"Low Engine Oil" Message

Service Category Engine/Hybrid System

Section Lubrication

Applicability

Figure 1. Warning Message Under the Speedometer

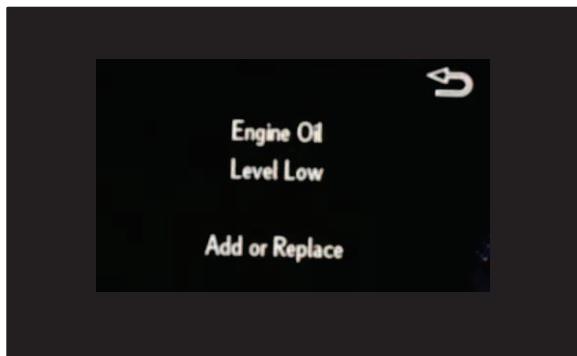
Some 2018 model year LS500 and LS500h vehicles may exhibit a warning message either under the speedometer ("Engine Oil Level Low Add or Replace") or on the Navigation screen ("Low Engine Oil"). Follow the Repair Procedure in this bulletin to address this condition.

4. Flash reprogram the combination meter ECU.

Follow the procedures outlined in Service Bulletin No. [L-SB-0001-18](#) "Techstream ECU Flash Reprogramming Procedure," and flash the combination meter ECU with the NEW calibration file update.
